INDIAN POINT NUCLEAR GENERATING UNIT NO. 3

Amendment No. 70  
License No. DPR-64

ATTACHMENT TO LICENSE AMENDMENT NO. 70

SAFETY EVALUATION BY THE OFFICE OF NUCLEAR REACTOR REGULATION  
RELATED TO AMENDMENT NO. 70 TO FACILITY OPERATING LICENSE NO. DPR-64

FIGURE 3.8-1

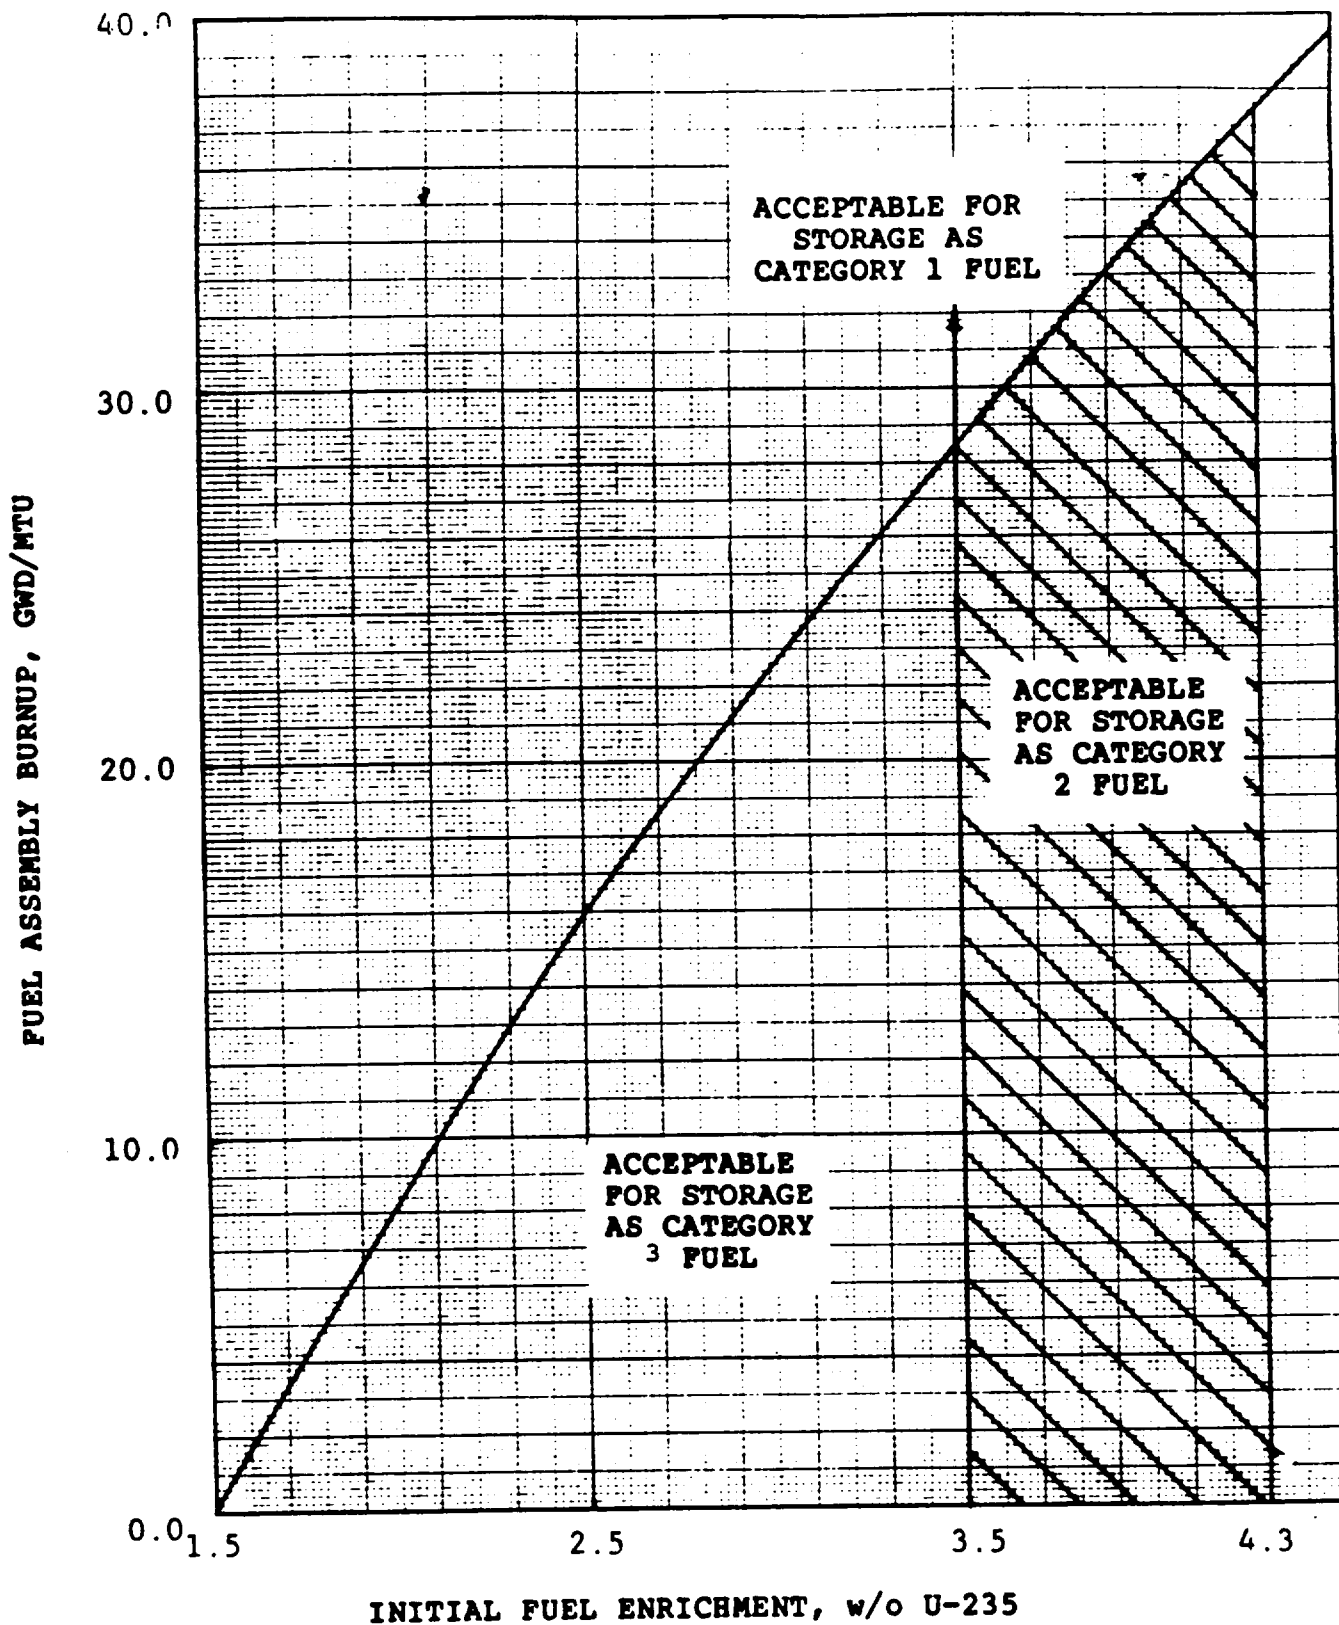
7. Fuel assemblies to be stored in the spent fuel pit can be categorized as either Category 1, 2 or 3 based on burnup and initial enrichment as specified in Figure 3.8-1. Category 2 fuel shall be loaded into the spent fuel pool storage locations in a checkerboard fashion with the intermediate storage locations containing Category 1 fuel, non-fuel materials or left empty. Unless restricted by the above, Category 1 or 3 fuel can be stored in any location in the spent fuel pool.

Fuel assemblies whose initial enrichment is greater than 3.5 w/o U-235 but less than or equal to 4.3 w/o can be stored in the spent fuel pool providing they are placed in a checkerboard array with fuel whose initial enrichment and burnup are sufficient to ensure that  $K_{eff}$  is less than 0.95 with no soluble boron present. This is ensured by categorizing the fuel whose initial enrichment is greater than 3.5 w/o U-235 but less than or equal to 4.3 w/o and whose burnup is below the curve of Figure 3.8-1 as Category 2. This fuel can be stored by checkerboarding with Category 1 fuel which is defined as fuel whose initial enrichment and burnup place it on or above and to the left of the curve in Figure 3.8-1. Category 3 fuel which is less than or equal 3.5 w/o U-235 and below the curve of Figure 3.8-1 cannot be used in the checkerboard with Category 2 fuel. Any Category 1 or 3 fuel can continue to be stored on a repeating x-y array with other non-Category 2 fuel. For the purpose of storing Category 2 fuel, non-fuel material or empty locations can be utilized in place of Category 1 fuel.

The method used for obtaining the constant reactivity curve for required burnup as a function of enrichment is the standard one used for rack criticality evaluations and is acceptable. The application of this method to the evaluation of checkerboard loading is also acceptable. The required burnup curve is obtained by first evaluating the rack multiplication factor for a checkerboard array consisting of fresh 4.3 weight percent and 1.5 weight percent U-235 fuel in alternating (checkerboard) locations. The value obtained for the multiplication factor was 0.901 for the Type A racks and 0.906 for the Type B racks. Next burned fuel having an initial enrichment greater than 1.5% weight percent was substituted for the 1.5 weight percent fuel and the burnup of that fuel was varied until the same multiplication factor was obtained. This process was repeated for several initial enrichment values up to 4.3 weight percent U-235. A curve of required enrichment as a function of burnup was then constructed and is included in the proposed Technical Specifications.

The licensee has proposed changes to Sections 3.8, 5.3 and 5.4 of the IP3 Technical Specifications. Section 3.8 has been amended to include the curve of required burnup as a function of initial enrichment and the restrictions on the storage of fuel with enrichment between 3.5 and 4.3 weight percent U-235. We have reviewed the proposed changes and conclude that they are consistent with the analysis provided and are acceptable. The changes to Sections 5.3 and 5.4 are merely to change the maximum permitted enrichment from 3.5 to 4.3 weight percent U-235 and are acceptable.
